Re: St. Anthony Plaza Apartments – Renovation
1750 INDIAN SCHOOL RD NW
Traffic Circulation Layout
Engineer's/Architect's Stamp 04-02-25 (H13D124)

ST ANTHONY PLAZA APARTMENTS
ALBUQUERQUE, NEW MEXICO
TRAFFIC CIRCULATION LAYOUT DETAILS

Re: St. Anthony Plaza Apartments – Renovation
1750 INDIAN SCHOOL RD NW
TRAFFIC CIRCULATION LAYOUT

SHEET
TCL-2
CPHAQNM.01

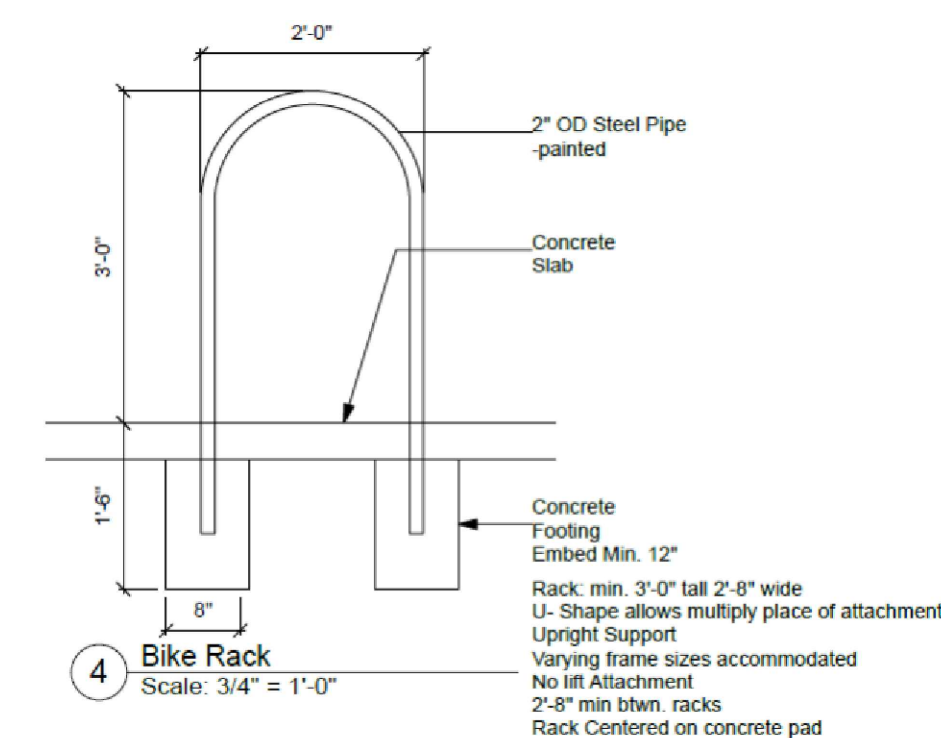
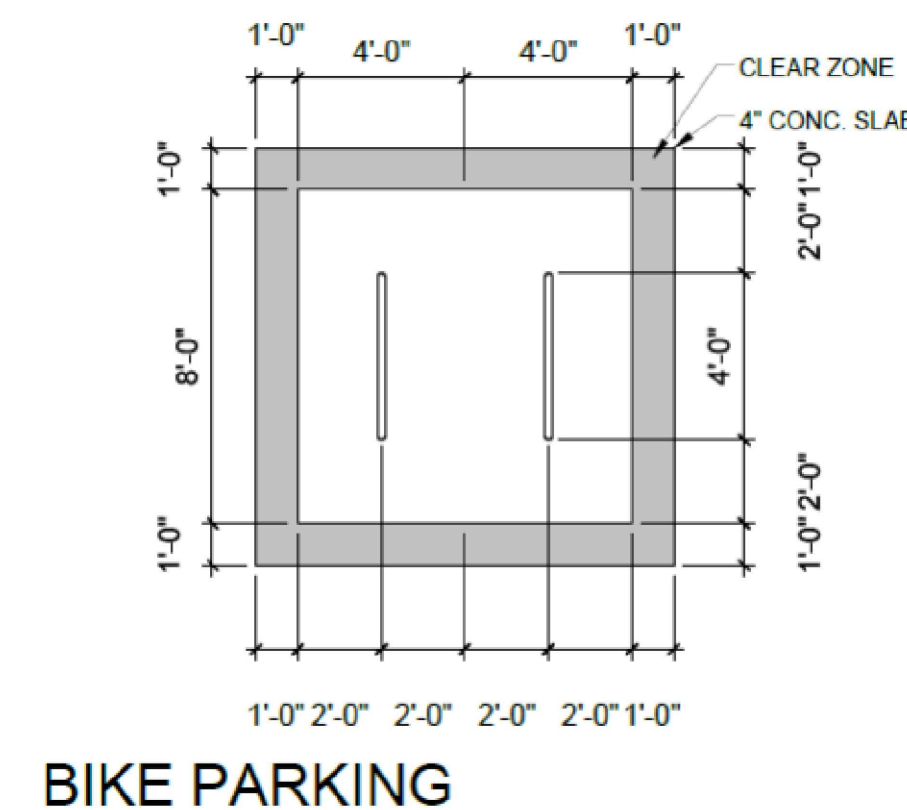
5. The HC parking widths and access aisles vary so it conflicts with using a standard detail with widths listed.

6. They do not call out where van accessible spaces and signs are.

Dimensions and handicap spaces have been restriped to be uniform. A note has been added to the typical detail to see plan for final dimensions.

Callouts have been added for the two van parking as well as callouts for the standard detail for the signs.
